SUBJECT: Forwards Rev 4 to "Diablo Canyon Unit 1 Inservice Insp & Testing Program Plan" & Rev 1 to "Diablo Canyon Unit 2 Inservice Insp & Testing Program Plan." Response to SSER 31 & justification for changes also encl.

Re: Docket No. 50-275, OL-DPR-80
Docket No. 50-323, OL-DPR-82
Diablo Canyon Units 1 and 2
Revisions to Inservice Inspection and Testing Program Plan

Response to SSER 31 Items Regarding DCP
Units 1 and 2 IST Program Plan

Justification for Additional Changes to DCPP Units 1 and 2 IST Program Plan

FIGURE 1

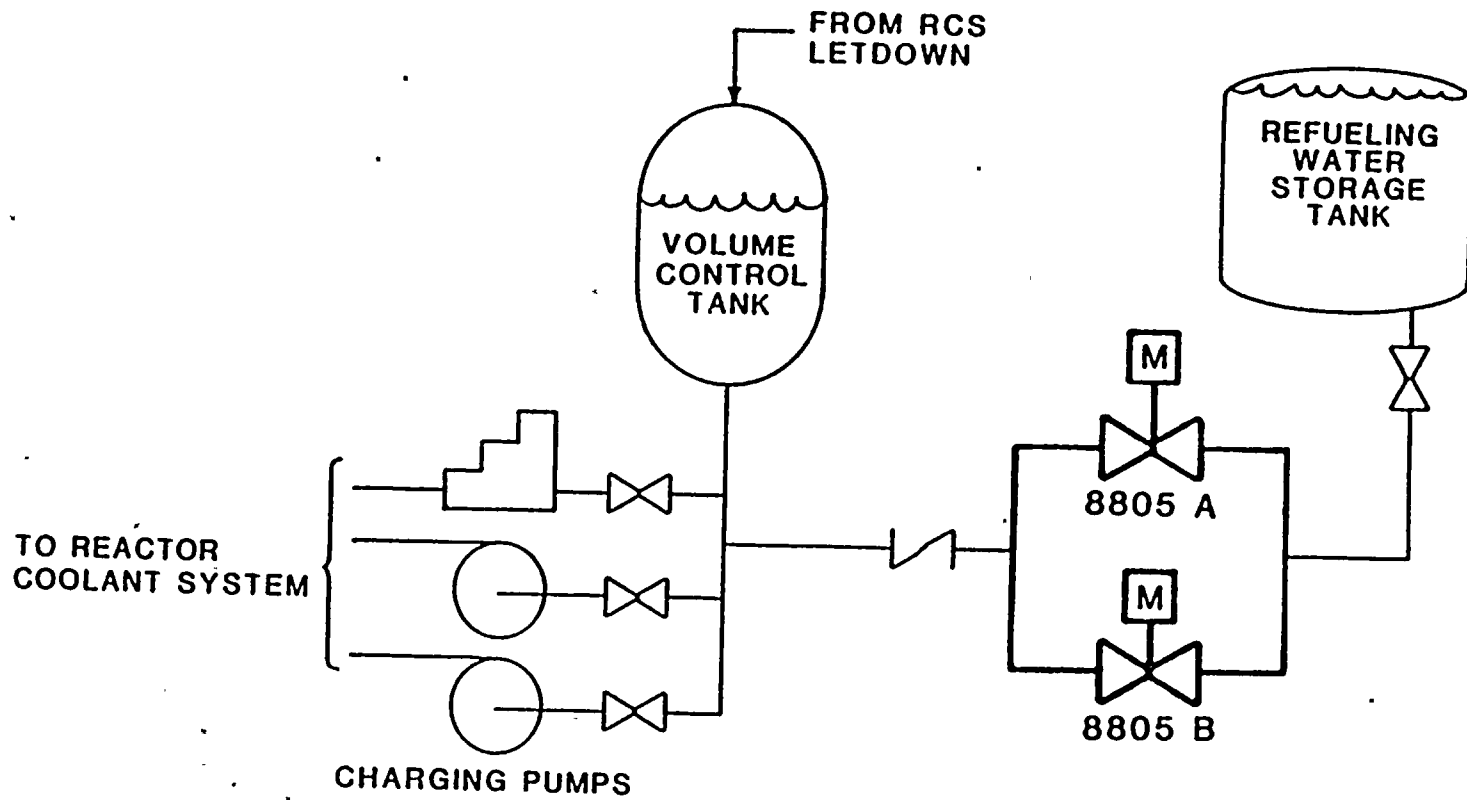
1. The Diablo Canyon Units 1 and 2 IST Program Plan (for valves) has been revised to add cold shutdown testing statement no. 28. This statement provides justification for changing the exercising frequency of valves 8805A and 8805B, from quarterly to cold shutdown. Exercising these valves during power operation injects highly oxygenated, 2000 ppm boric acid from the refueling water storage tank (RWST) into the reactor coolant system (RCS) via the charging pumps. Injecting this water into the RCS is undesirable for two reasons:

- a. The RWST water is fed directly to the suction of the charging pumps and injected into the RCS. Since the water is not subjected to the hydrogen overpressure in the volume control tank, its high oxygen content is not scavenged. This causes accelerated corrosion of RCS components, particularly the charging line to RCS nozzles.

- b. Injecting the 2000 ppm boric acid from the RWST into the RCS causes a reactivity addition. This is especially of concern late in core life when the RCS boron concentration is extremely low.

Figure 1 shows the component configuration for valves 8805A and 8805B.
